FINAL DRAINAGE REPORT – ADDENDUM NO. 1

ARACO ENTERPRISES LLC - BUILDING ADDITION 7470 SOUTHMOOR DRIVE, FOUNTAIN, CO

May 1, 2024

**JPS Project No. 111705
PPR-1950**

DEVELOPED DRAINAGE PLAN

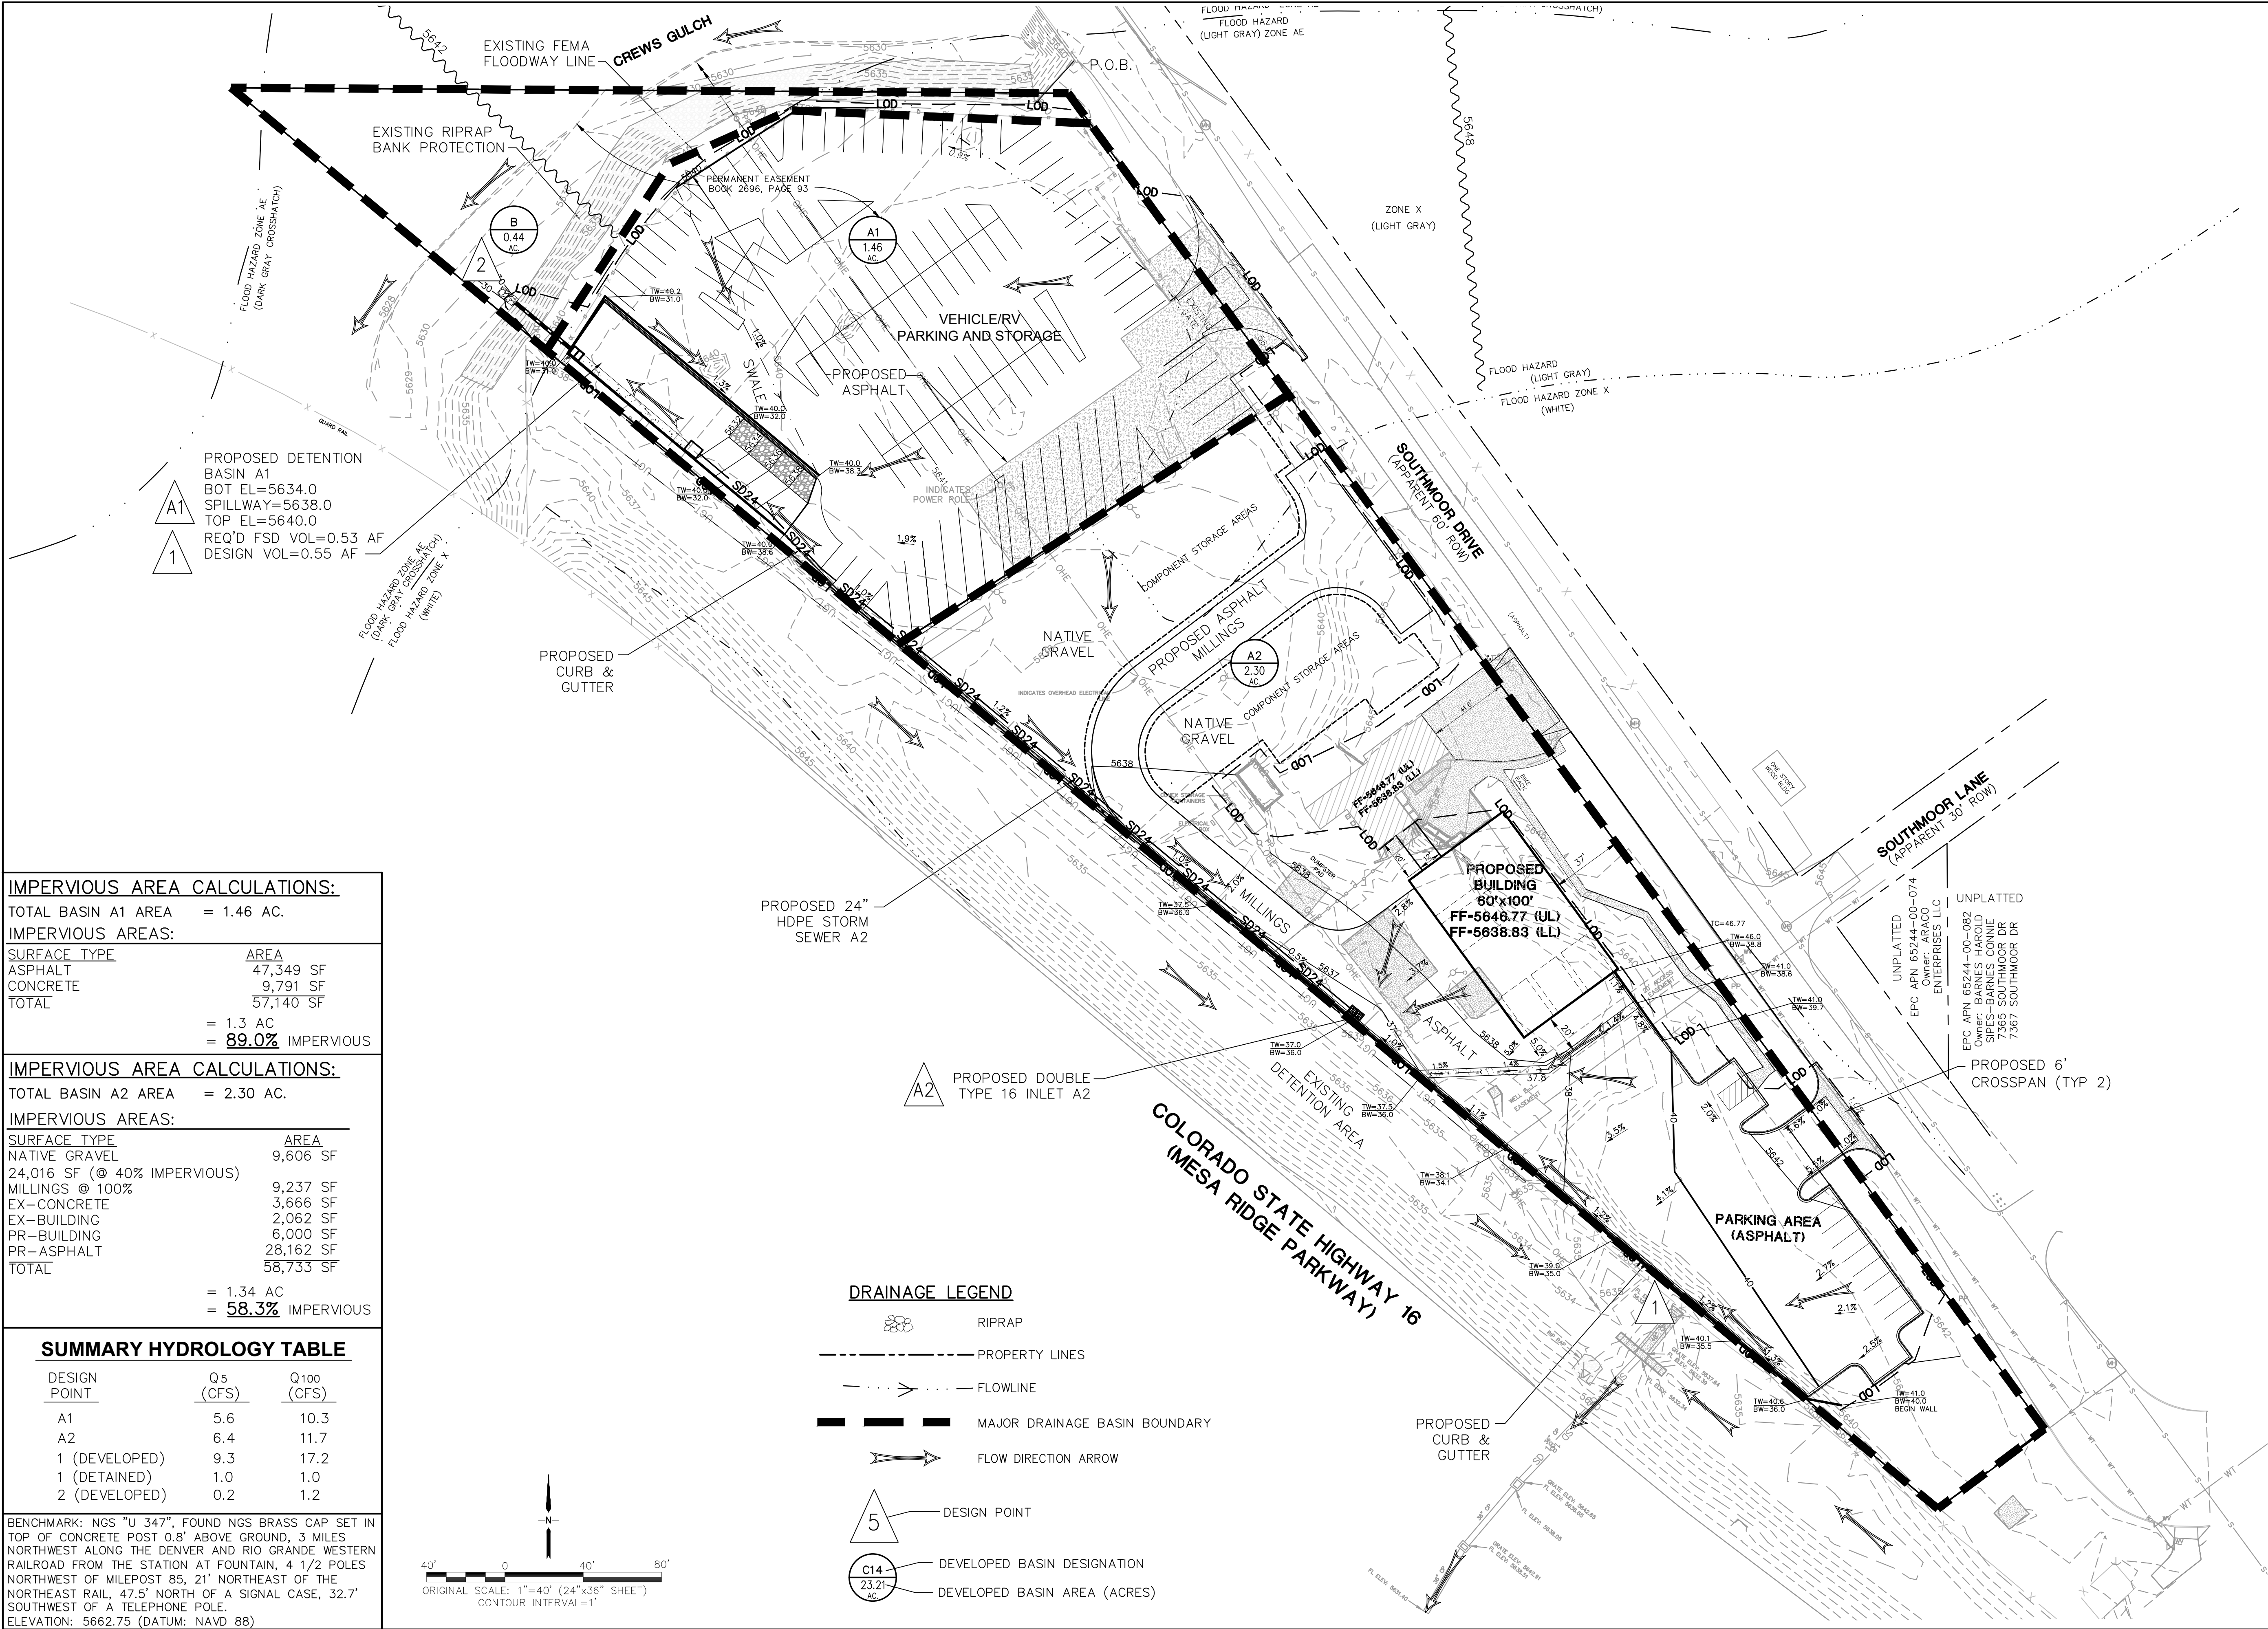
The developed drainage basins and projected flows are shown on the attached Figure D1 (Appendix C). The previously depicted Detention Basin A2 (near the southeast corner of the site) has been eliminated, and the proposed Detention Basin A1 at the northwest corner of the site has been enlarged to meet all of the required on-site stormwater detention and water quality requirements.
